ENGINE - FUEL AND CONTROL - INTRODUCTION OF TUBES MADE OF IMPROVED FRETAGE RESISTANT  
MATERIAL - CATEGORY CODE 6 - MOD.ENG-73-0045

V2500-ENG-73-0045

Location of clip points 0302, 0304, 0305, 0306 and 0319  
Fig.1, Sheet 1 of 4

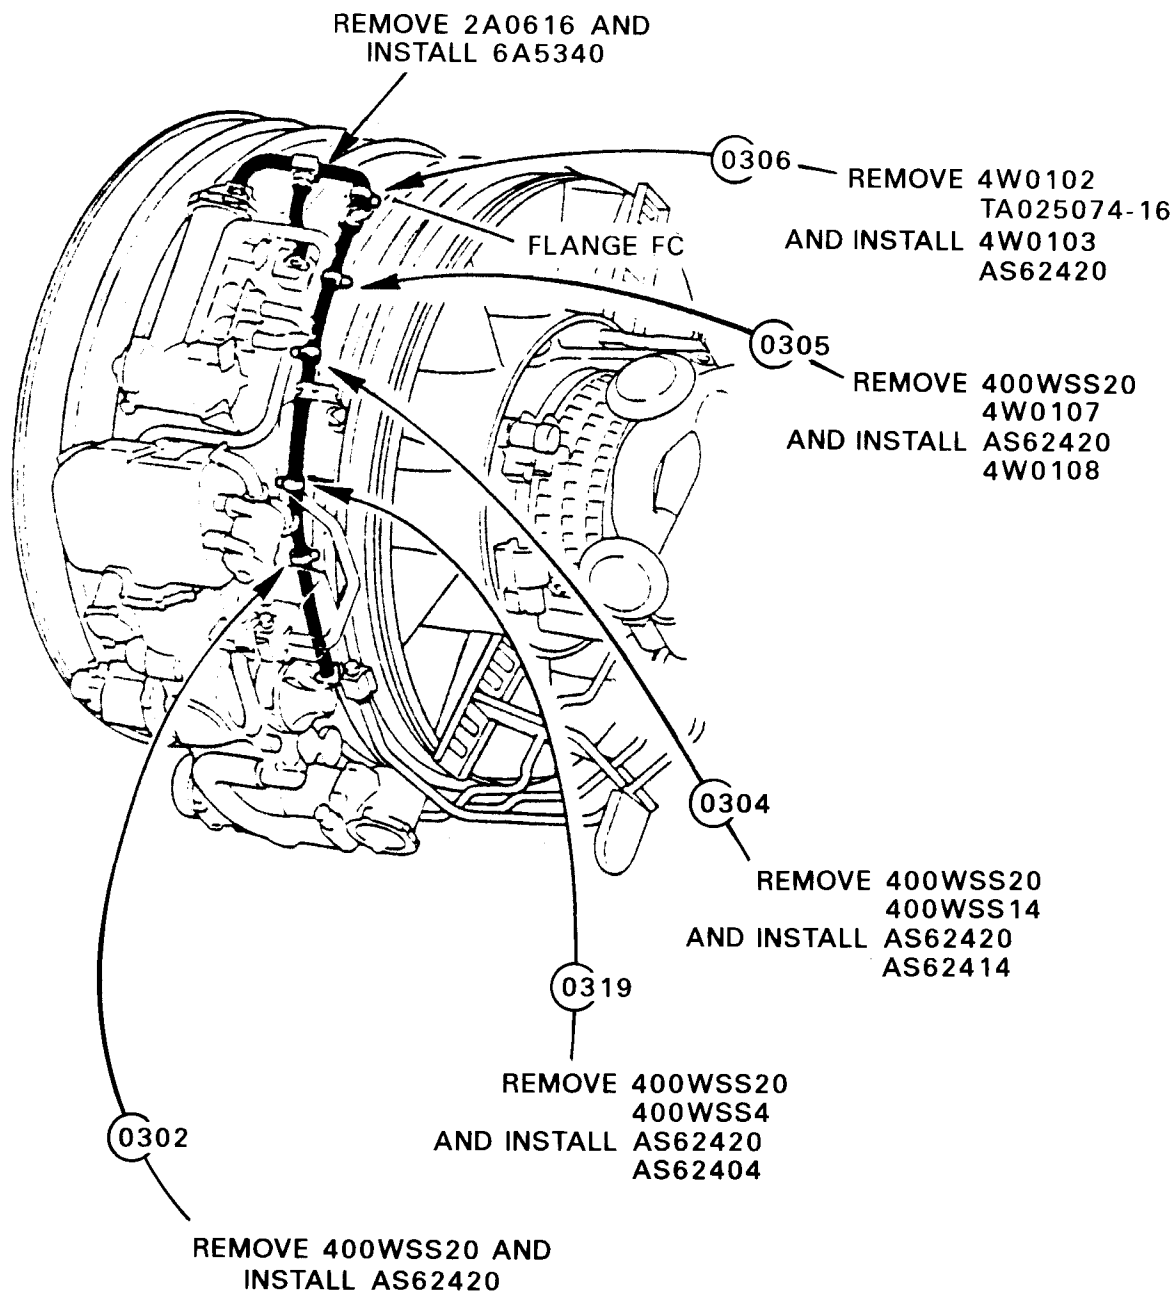
This Service bulletin introduces 8 steel tubes to replace existing titanium tubes. The 'Adel' type clips used with the titanium tubes are replaced with clips from the 'AS' range. The 'AS' clips have marginally thicker lugs compared to the 'Adel' clips, and this has necessitated the use of longer bolts at clipping points 0305 and 0306 to maintain the minimum bolt protrusion.

and 4 Location of clip points 0253, 0255, 0921, 0922, 1033, 1038, 1040, 1070 and 1072  
Fig.1, Sheet 3

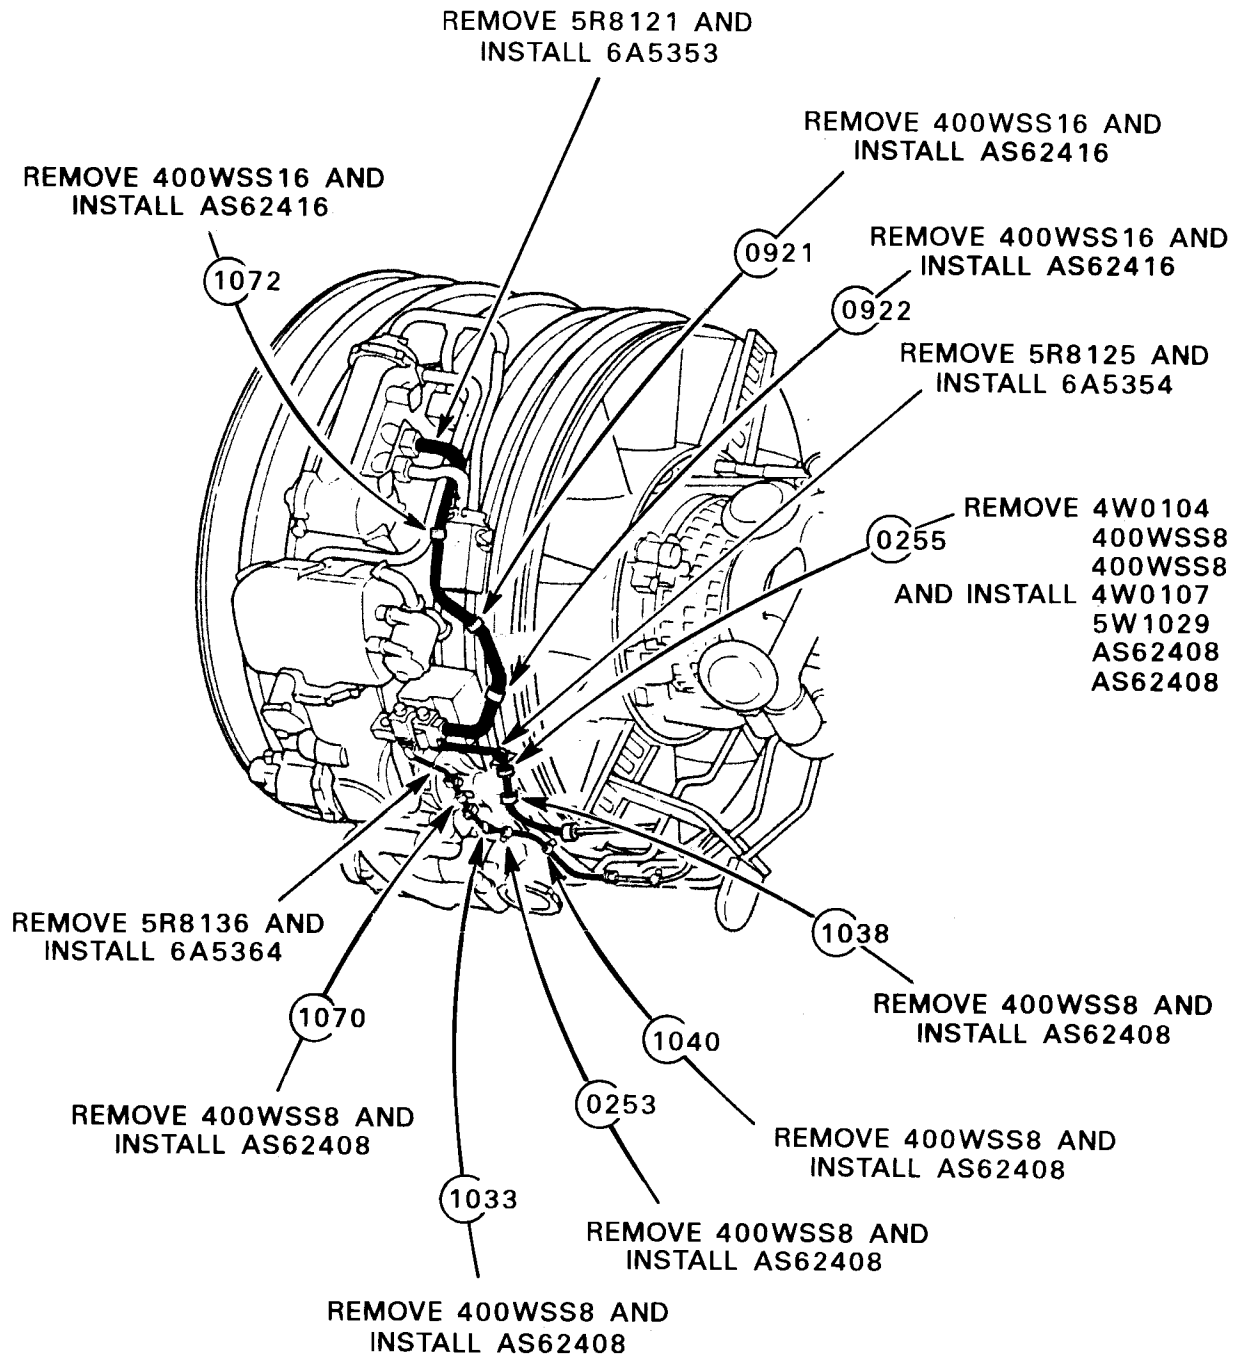
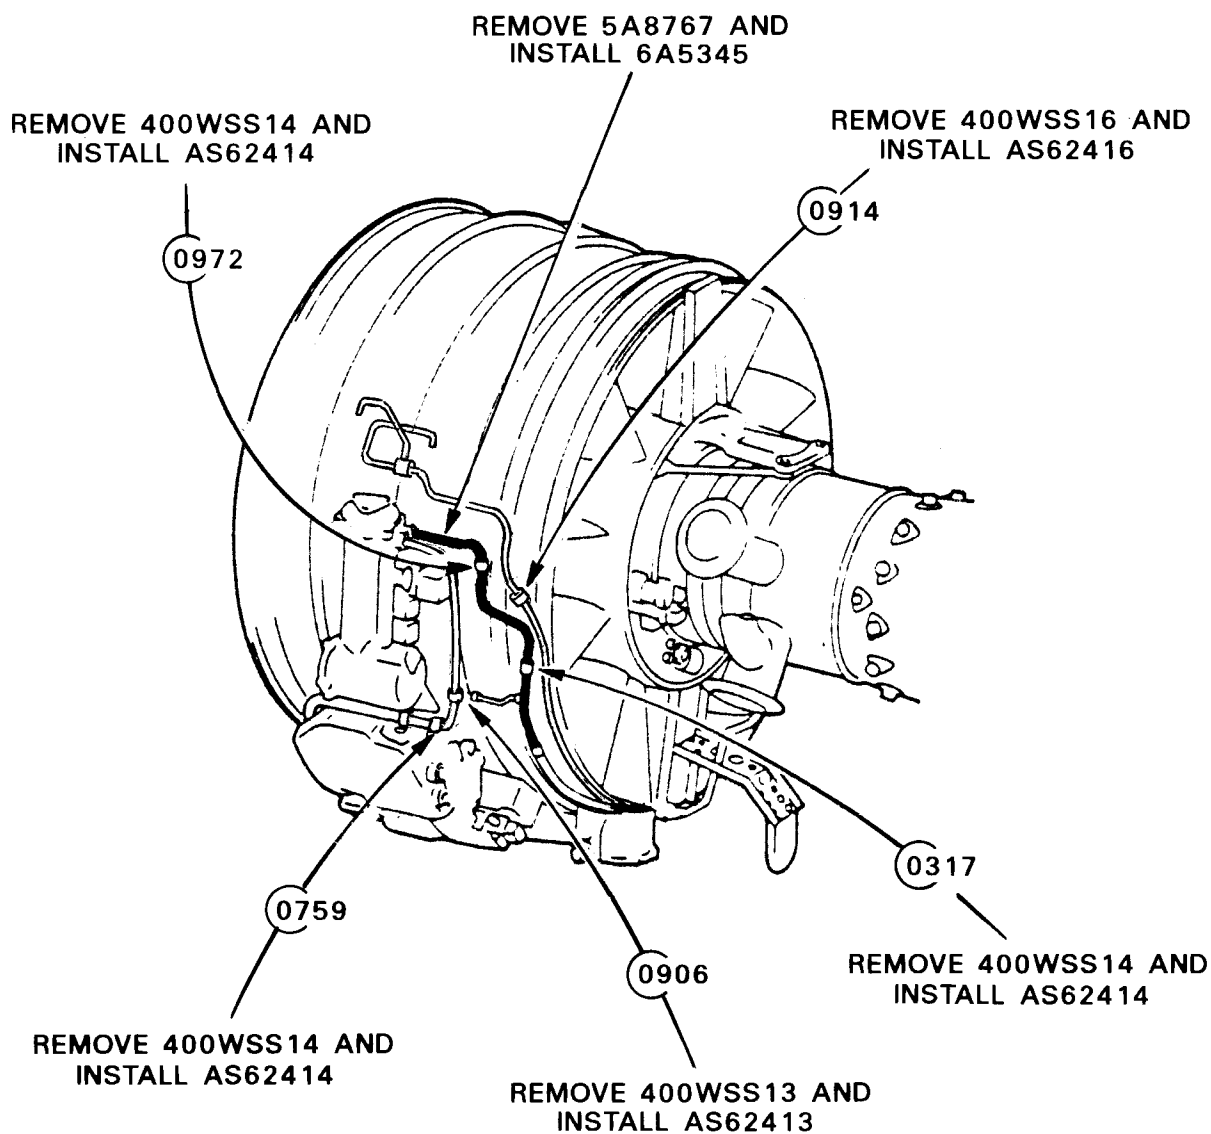
Clipping arrangements remain unchanged except at CP0255 where a 5 mm spacer is introduced to improve the clipping at this location.
